# UNITED STATES PATENT AND TRADEMARK OFFICE

10/728,324

**Office Action Summary**

## DETAILED ACTION

**Fig. 3**

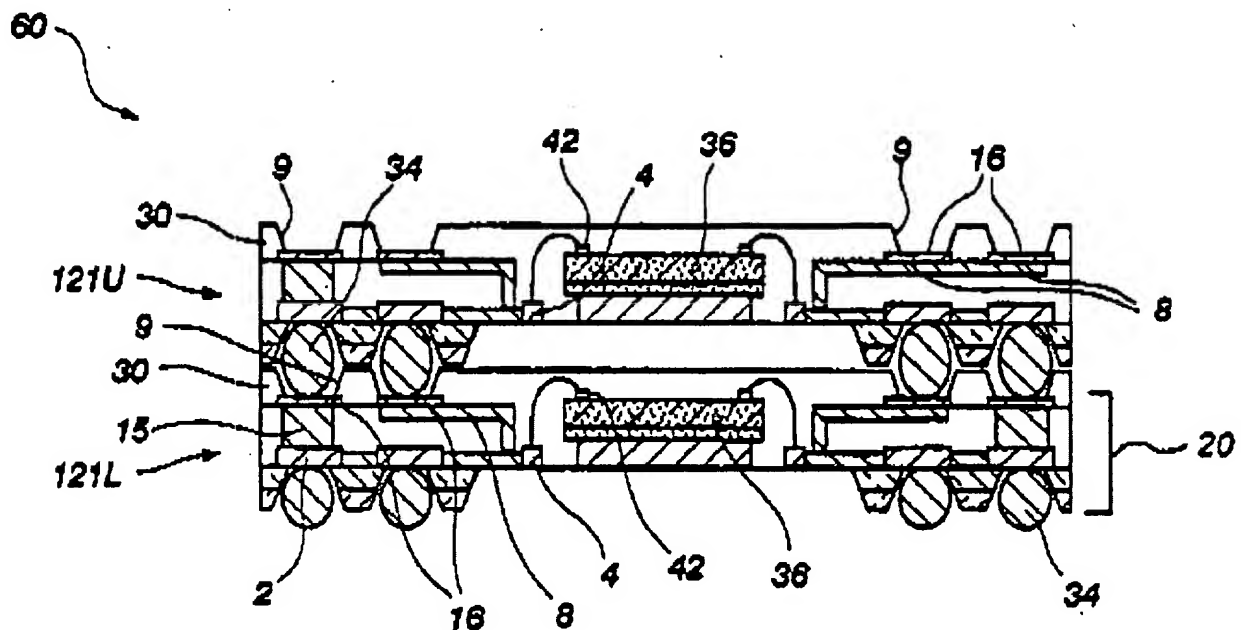
Taniguchi does not show that the second interconnect is in contact with the first interconnect within the opening. However, Lee (e.g. fig. 3) shows an interconnect having a first interconnect (2/15/16/34) and a second interconnect (2/15/16/34) wherein the second interconnect is in contact with the first interconnect within the opening. This limitation has been interpreted in light of the specification as a solder ball partially located within an opening in contact with a pad of an upper circuit package. In this case, the solder ball 34 is analogous to the ball 21 described in figure 1 of the instant invention.

It would have been obvious to one of ordinary skill in the art at the time the invention was made connect the second interconnect the first interconnect disclosed by Taniguchi within the opening to make a package having a reduced thickness as taught by Lee (see col. 3/lis. 17-40).
